MINUTES of the duly convened Ordinary Meeting of The Hills Shire Council held in the Council Chambers on 27 November 2018

ITEM-2 POST EXHIBITION - PLANNING PROPOSAL - CASTLE HILL NORTH PRECINCT (16/2016/PLP)

| ITEM-2 | POST EXHIBITION - PLANNING PROPOSAL - CASTLE HILL NORTH PRECINCT (16/2016/PLP) |

The purpose of this report is to consider the outcomes of the public exhibition of the Castle Hill North Planning Proposal (16/2016/PLP), draft Contribution Plan, draft Development Control Plan Sections (Castle Hill North and Parking) and the draft Public Domain Plan.

Figure 4
Key Site Map

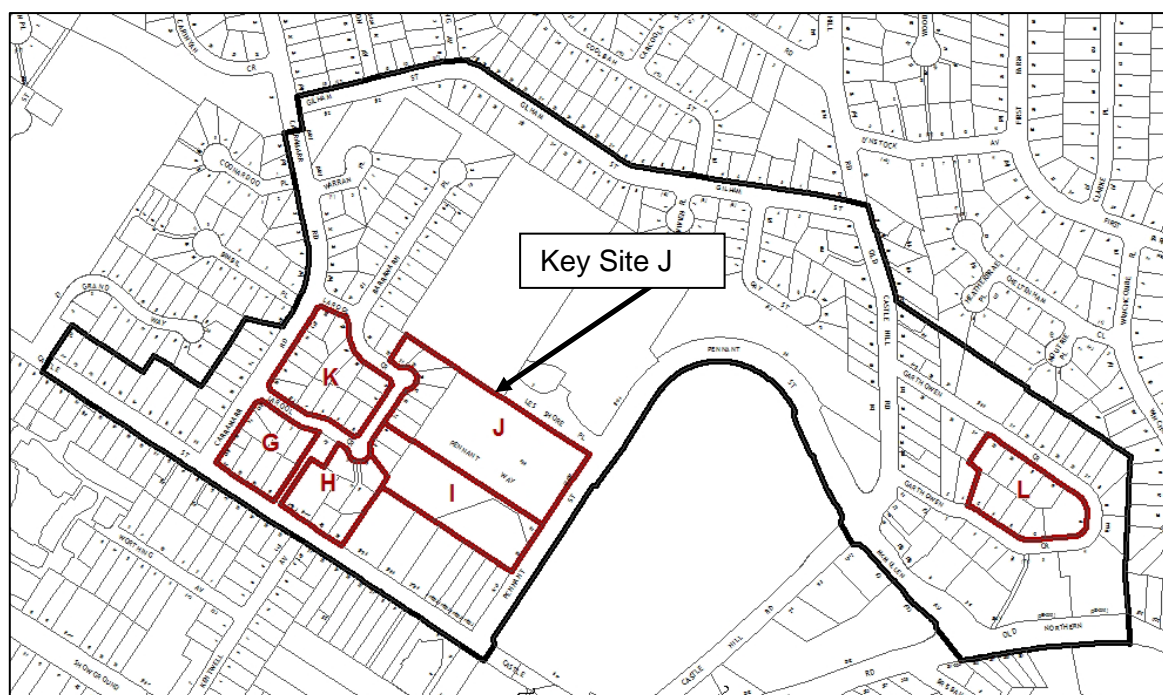
LAHC have noted that within the exhibited Planning Proposal the criteria for Key Sites I and J were inadvertently swapped. Furthermore, the submission states that the intent of the provision is to amalgamate the 6 individual lots fronting Larool Crescent and provide a through site pedestrian link and active street frontage to Pennant Street. LAHC have raised concern that the manner in which the key site provision is structured will force the amalgamation of the subject site with the 6 individual lots fronting Larool Crescent which would be difficult to achieve due to the financial outlay required to purchase each property which is compounded by the expectations created by recent property sales in the area.

- Update the criteria to swap the criteria for Key Sites I and J;
- Amend the Key Site Map to remove the Larool Crescent lots from Area J;
- Maintain the 20% bonus for providing a publicly accessible through site pedestrian link from Les Shore Place to Larool Crescent;
- Increase the proposed incentive FSR on 24-26 Pennant Street by 0.1:1 (from 2.2:1 to 2.3:1) - This is equivalent to the resultant FSR increase if a single lot were added to the site area of 24-26 Pennant Street and the 2.2:1 incentive FSR applied. Justification provided by LAHC is that this increase in FSR would offset the cost of acquiring an additional lot and would partially avoid a loss in social housing as a result of the acquisition.

The submission is correct in that the exhibited Planning Proposal inadvertently swapped the criteria for Key Sites I and J. Accordingly, it is recommended that the Planning Proposal be amended to swap the Key Site criteria for sites I and J. With respect to the Key Site Map and Incentive FSR it is recommended that these remain as exhibited. It is considered that the exhibited standards will facilitate a viable high density development outcome on the site. If LAHC do not intend to amalgamate with the lots along Larool then they can simply develop at the incentive FSR, and will not be eligible for the 20% floor space bonus. Nothing in the proposal obligates LAHC to amalgamate with the adjoining sites.

Figure 7
Proposed Road Section with Increased Lane Widths – Old Castle Hill Road

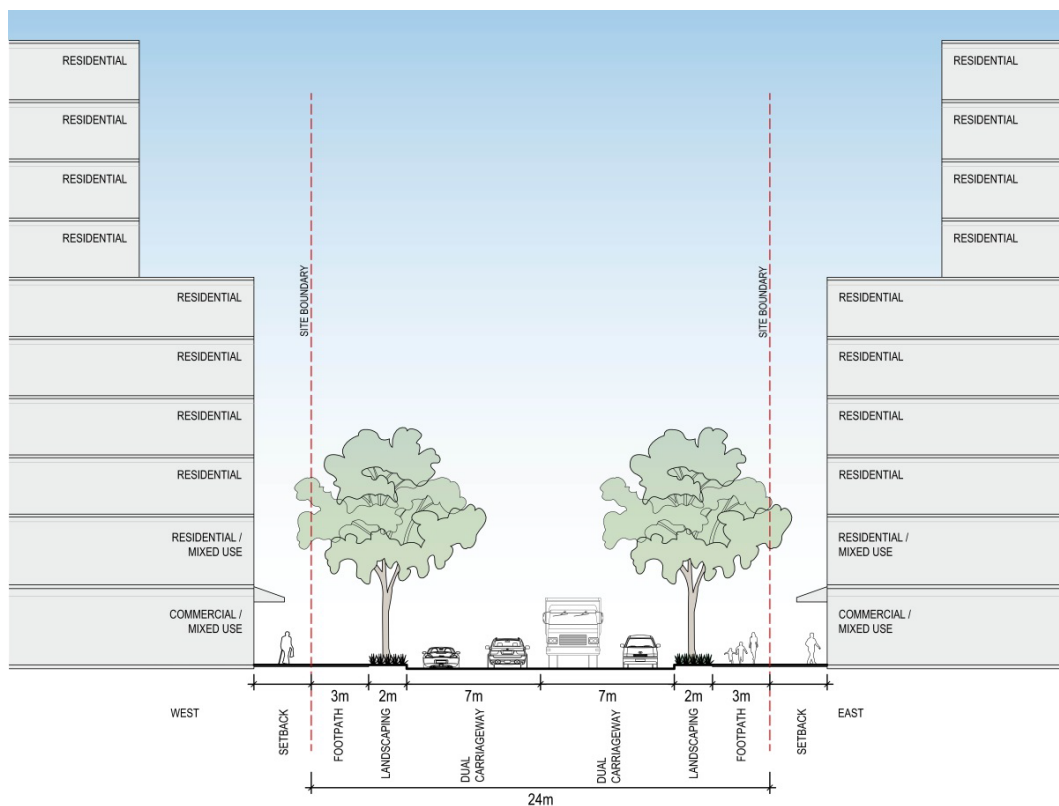
It is considered appropriate to facilitate safe and efficient local bus services through the Precinct. Given the planned widening of Castle Street and Old Castle Hill Road, it is considered reasonable to redistribute the profile to provide 3.5m travel lanes along these roads, consistent with the desirable lane widths within the NSW Transit Bus Infrastructure Guide. For Old Castle Hill Road, it is proposed to remove the proposed 1.2m median, given that the exhibited median width is not of sufficient size to support significant landscaping, and reallocate the space to provide 3.5m travel lanes in each direction. For Castle Street, it is proposed to slightly reduce the proposed width of the northern verge by 0.5m and reallocate the space to provide two 3.5m travel lanes. The remaining verge would be 3.85m wide which still provides sufficient width for a footpath and landscaping. Whilst the verge width has been reduced, buildings will be setback 3m from the property boundary and a 2.55m bike lane will be provided along the northern side of the roadway which provides

sufficient separation between pedestrians and vehicular traffic. The revised street profiles are provided below.

Figure 9
Proposed Road Section – Garthowen Crescent

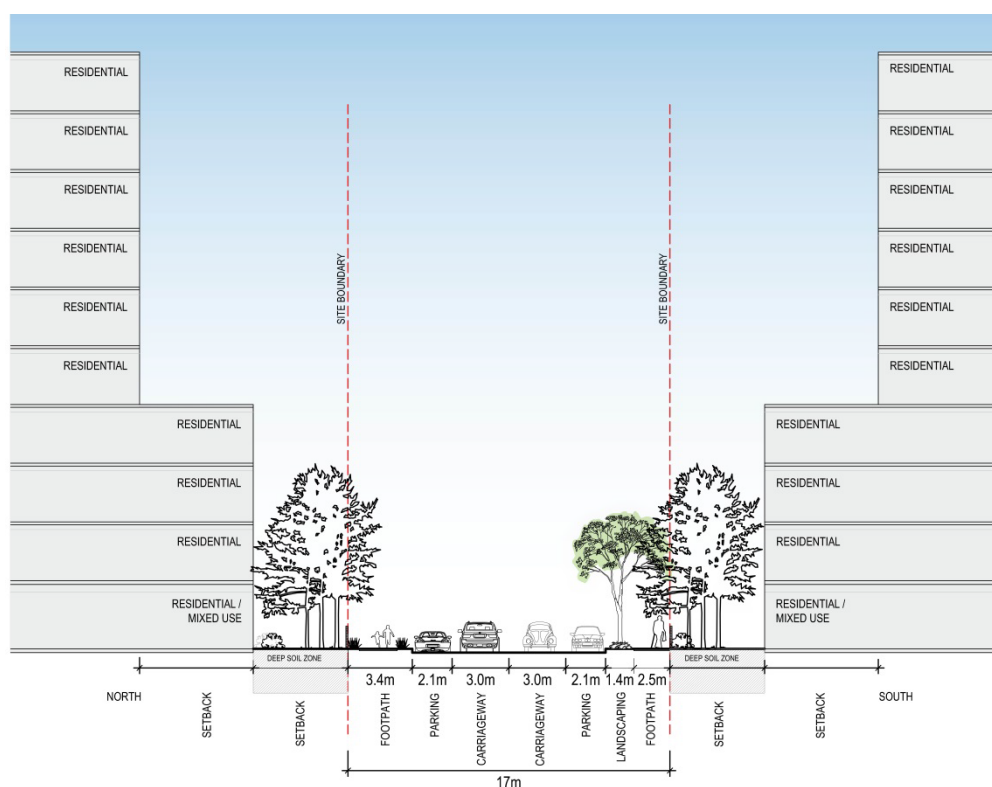
Concern has been raised that the proposed land dedication plan for Garthowen Crescent applies to land that is not proposed to be rezoned.

Currently the road reservation for Garthowen Crescent is around 15-16 metres, with a 7.5m carriageway width, which is quite narrow. As higher density development occurs, the carriageway and road reservation will need to be widened in certain locations to facilitate improved vehicular movement and safety. The proposed street section within the exhibited DCP proposed a 17 metre road reservation with a 10.2 metre carriageway width. An extract of the proposed street section is included below. It is recognised that as part of the detail design of the future road upgrade, parking may not be able to be provided for certain sections of the roadway or in some instances may only be provided on one side, due to poor sight distances.

Figure 11
Properties around Grand Way

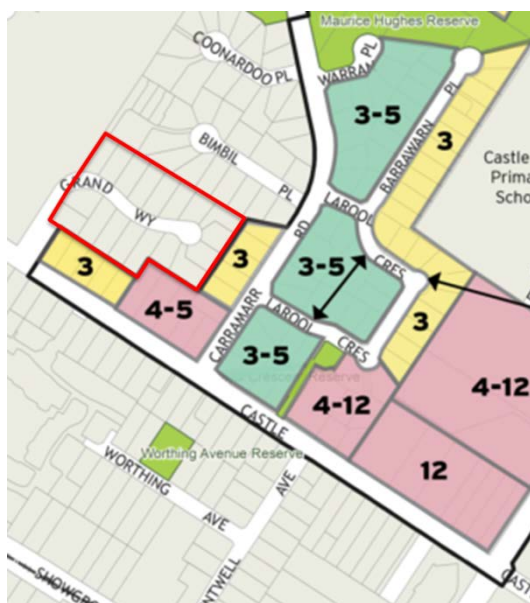
A number of submissions requested additional sites be included within the precinct. Requests for inclusion generally stem from a desire for redevelopment opportunities or concerns relating to perceived amenity impacts or reduction in property values if left out of the precinct. The subject properties which have requested to be included are identified in the figures below.

As the Castle Hill North Precinct has already been subject to an extensive master planning process, the inclusion of additional sites within the precinct following the public exhibition period is not considered to be appropriate as it would necessitate the issue of a revised Gateway Determination from the Department of Planning and Environment and re-exhibition of the planning proposal.

Land bound by Gay Street, Gilham Street and Old Castle Hill Road

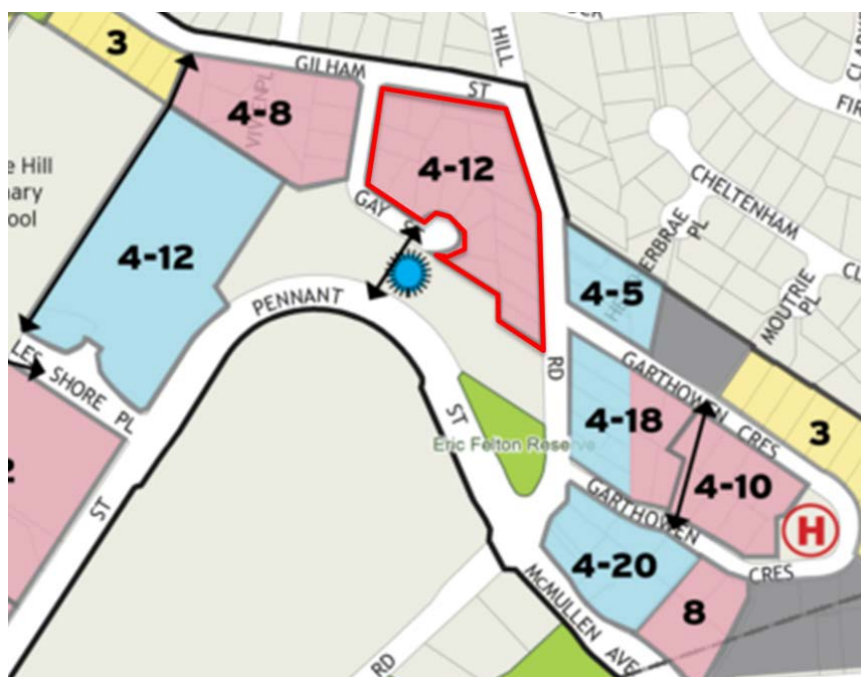
The submission in relation to these properties (outlined in red in the figure below) requests the land to be considered for additional density. The request is made primarily on the basis of the proximity to the Castle Hill Station and the higher densities applicable to surrounding sites including Pennant Street Target Site and properties within Vivien Place subject to a separate planning proposal (2/2017/PLP). The land is proposed to be rezoned R4 High Density Residential under the current planning proposal and the DCP envisages the site will accommodate high density residential development with heights up to 12 storeys. The submission requests that Council provide an incentive uplift if all properties are amalgamated through a development application and the site is developed logically in a non-piecemeal basis.

The request for additional density at this location is not considered necessary. There is sufficient opportunity for redevelopment afforded by the proposed standards including an Incentive FSR of 2.04:1 where development complies with the housing diversity requirements. Whilst the proposed density and heights are lower than the adjoining target site, this is to assist in providing a transition from sites closest to the centre to lower density development outside of the precinct. Further, uplift being proposed for land within Vivien Place (subject to a separate planning proposal) is intended to facilitate the delivery of a future road link connecting Les Shore Place and Gilham Street which is a considerable public benefit. Accordingly, no change to the planning proposal as exhibited is considered warranted for these sites.

Land within Barrawarn Place

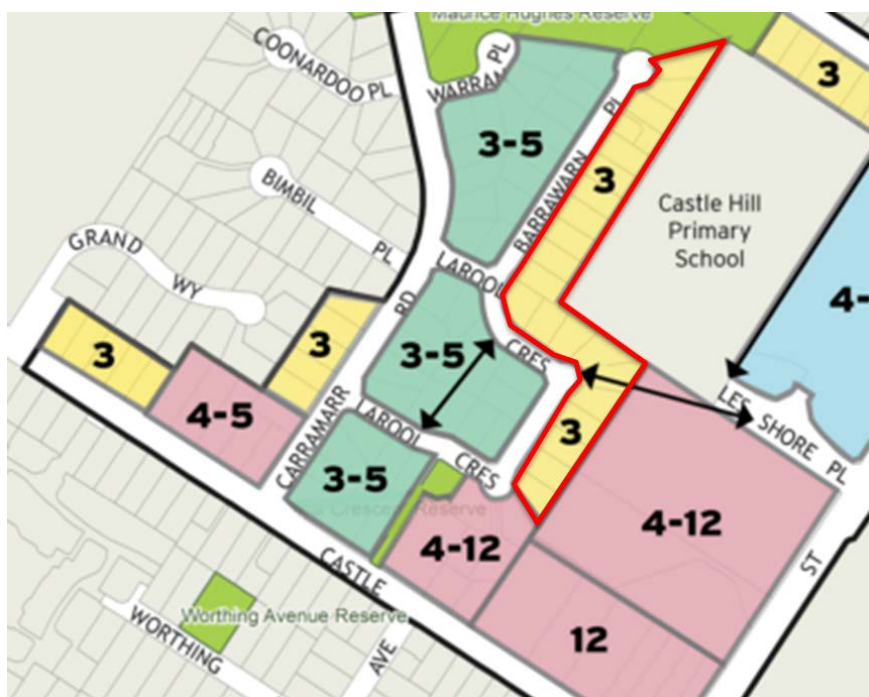
These submissions relate to a strip of properties within Barrawarn Place (outlined red in the figure below) which are proposed to be rezoned R3 Medium Density Residential and for which the DCP envisages three storey terrace outcomes. The submissions request the planning controls for the subject sites be amended to facilitate 3-5 storey development consistent with the western side of Barrawarn Place and Larool Crescent. Alternatively, it is requested that both sides of Barrawarn Place be identified for three storey terrace development. The requests are made on the basis that Proposal is inconsistent with the principle of containing the highest densities closest to the centre and that surrounding future development will overshadow the subject land creating adverse amenity impacts and reduced property values.

Locations for higher density housing within the Castle Hill North Precinct have been identified by factors including proximity to the future railway station and Castle Hill centre and amalgamation opportunities. Medium density outcomes have been identified for sites in the periphery of the Precinct, and where there are constraints such as shallow lot depth and interfaces with low density housing and sensitive land uses, such as Castle Hill Primary School. Given the narrow depth of the subject properties, there would be insufficient room to accommodate satisfactory setbacks to provide an appropriate degree of separation of future development to the primary school. The site constraints inhibit the ability of residential flat building development on the site to meet key design requirements specified within Council's DCP.

Figure 15
Land at 15-31 Garthowen Crescent

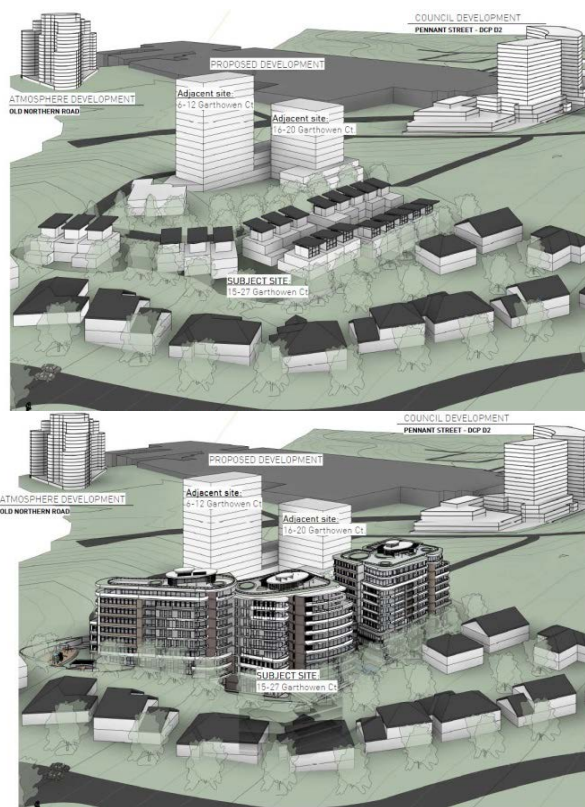
The submission requests that the subject properties be zoned R4 High Density Residential to facilitate two 8 - 10 storey residential flat buildings with rooftop communal open space. They suggest that the subject site has a shorter walking distance to Castle Hill Railway Station than other sites in the precinct that are identified for 12 storeys, with the proposal being inconsistent with the aim of providing higher density residential development within close proximity to high frequency public transport services.

Concern was expressed that a townhouse scheme on the subject site is inappropriate, with a need for a better transition to higher scale developments in the vicinity. Concept plans were provided to illustrate both a residential flat building and a townhouse outcome to support their proposal (as shown below). The submission requests that the planning proposal be amended to reflect their development concept.

The subject sites are currently zoned R3 Medium Density Residential under LEP 2012. It is proposed to retain this zoning in the Castle Hill North Planning Proposal, and the Draft DCP anticipates 3 storey terraces in this location. Land to the north of Garthowen Crescent is zoned R2 Low Density Residential and is not included in the subject planning proposal.

Planning controls for Garthowen Crescent must respect the sensitive interfaces with the heritage-listed Garthowen House and adjoining low density residential dwellings. A 3 storey terrace development on 15 – 31 Garthowen Crescent will provide a suitable transition of built form and heights to the adjoining low density dwellings to the north and is appropriate for the future intended character and streetscape of the area. Accordingly, no change is recommended to the exhibited planning controls.

Target site (yellow outline) and 55 Old Castle Hill Road (red outline)

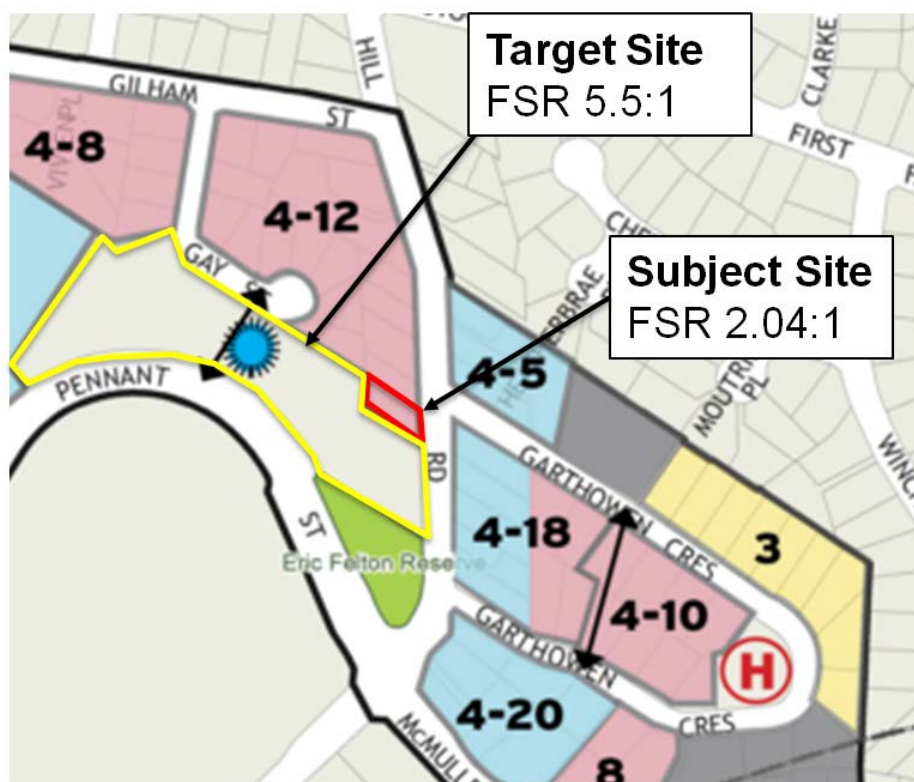
One submission has requested that the proposed planning controls for 55 Old Castle Hill Road (outlined red below) be amended to reflect the controls applicable to the Pennant Street Target Site (outlined yellow below). Specifically, it requests the planning controls be amended as follows:

- Application of a floor space ratio of 5.5:1 (rather than a Base FSR of 1:1 (and Incentive FSR of 2.04:1 as is currently proposed);
- Application of a height of buildings of 54m (rather than no height as currently proposed); and
- Application of a minimum lot size of 700m² (rather than 1,800m² as currently proposed).

Application of the standards applicable to the Target Site will facilitate additional yield above what has been envisaged for the site within the Castle Hill North Planning Proposal. Whilst the potential yield created by the subject site (approximately 30 dwellings) may not, in isolation, create the need for new local infrastructure facilities, it is crucial to consider the cumulative impact of incremental uplift and growth on local infrastructure provision. As the proposed density exceeds that envisioned under the Castle Hill Contribution Plan the additional demand on public infrastructure has not been accounted for. Accordingly, it is recommended that no change be made to the development standards applying to 55 Old Castle Hill Road.

24 to 30 Old Castle Hill Road and 2, 24 and 28 Garthowen Crescent

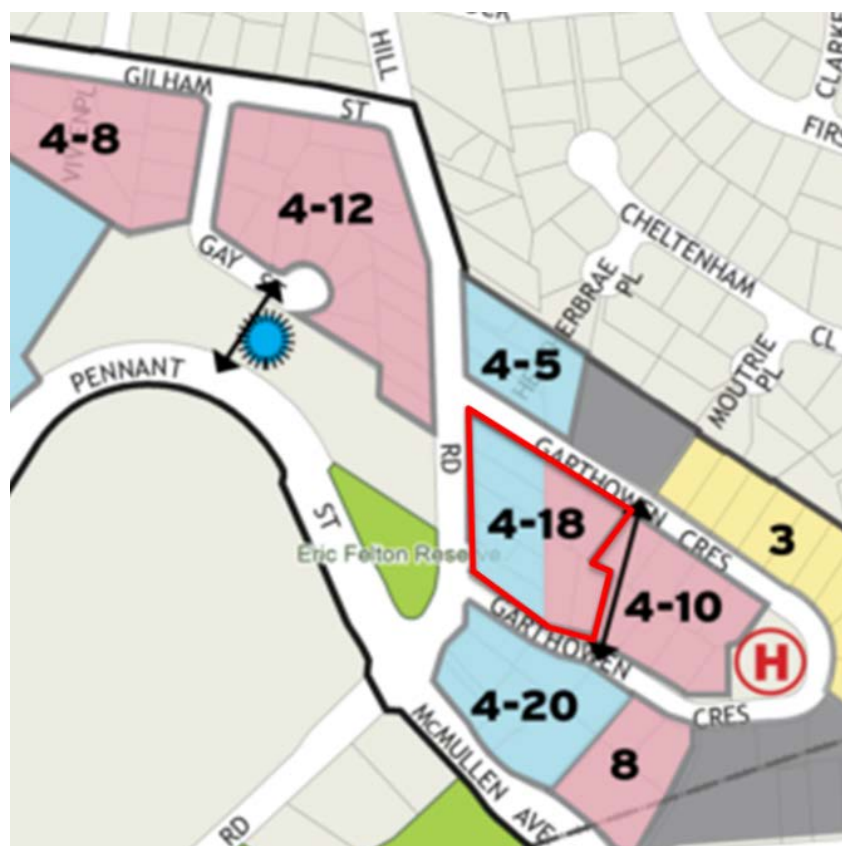
One submission has raised concern with respect to the proposed DCP controls applicable to a number of properties generally bound by Garthowen Crescent and Old Castle Hill Road (outlined in red in the figure below). Specifically, the submission raises concern with the viability of retail and commercial uses within the R1 General Residential zone at this location, given the proximity of the site to the centre core. Additionally, concern is raised that the site coverage, building height, landscaped area and setbacks will not allow a building envelope capable of achieving the floor space ratio identified within the planning proposal for the subject land. The submission requests Council to review the DCP controls, limit non-

It is not considered necessary to rezone the subject land from R1 General Residential to R4 High Density Residential. The R1 General Residential zone reflects the desire for uses that encourage activation, provide employment and meet the day to day needs of future residents. Whilst the DCP stipulates appropriate uses for the ground and first floors, there is flexibility in the assessment of future development applications to consider suitability/viability of such uses. It is considered appropriate to retain the desired land use character for the entire strip along Old Castle Hill Road rather than amend controls for the subject site in isolation.
